Work Order ID 52827

Item Name: Crosstube Turning Detail

DESIGN PH	DRAWN BY PH	DART AEROSPACE LTD HAWKESBURY, ONTARIO, CANADA	
CHECKED QP	APPROVED PH	DRAWING NO. D212-664-141	REV. C SHEET 1 OF 3
DATE 07.03.08		TITLE XTUBE ASS'Y (205/212/412 HI FWD) NTS	
A	00.12.12	NEW ISSUE	
B	05.02.04	ADD HOLES FOR COMPATABILITY WITH BHT/AA SKIDTUBES	
C	07.03.08	REMOVE -851 ABRASION STRIP; ADD MAGNOBOND 6398, CUSHION, REVERSE CLAMPS

DRAWING NO. D212-664-141	TITLE CROSSTUBE	REV. C	DART AEROSPACE LTD ENGINEERING ORDER		D.E.O. NO. D212-664-141-C-1	SHEET NO. SHEET 1 OF 1	SCALE NTS
DRAWN <i>AD</i>	CHECKED <i>RS</i>	MFG. APPR. <i>RE</i>	APPROVED <i>MD</i>		DE APPR. <i>MD</i>		
DATE 09.05.01	DATE 09.06.15	DATE 09.06.15	DATE 09/06/16		DATE 09/06/16

FIGURE 1 - SUPPORT INSTALLATION

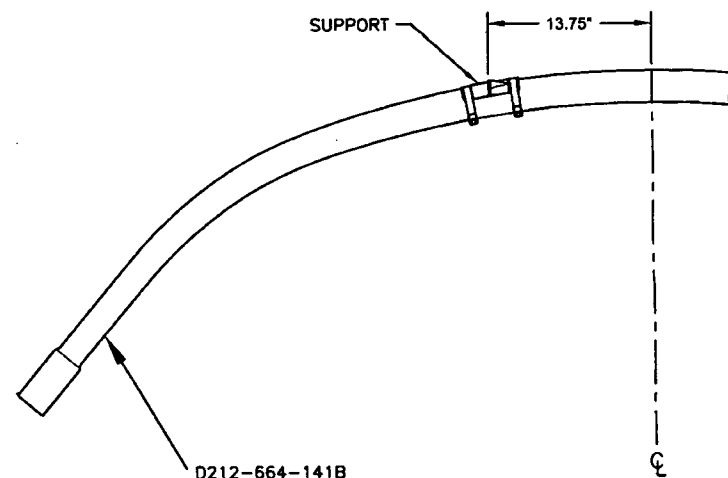
CHANGE:

ADD THE FOLLOWING CROSSTUBE ASSEMBLY:

Part Number	Description
D212-664-141B	CROSSTUBE ASSEMBLY (214 HIGH FWD)

THE D212-664-141B CROSSTUBE HAS THE SAME PARTS LIST AS THE D212-664-141 CROSSTUBE. HOWEVER, INSTALL THE SUPPORTS AS SHOWN IN FIGURE 1 OF THIS ENGINEERING ORDER. THE NEW KIT IS OTHERWISE ASSEMBLED PER THE D212-664-141 CROSSTUBE.
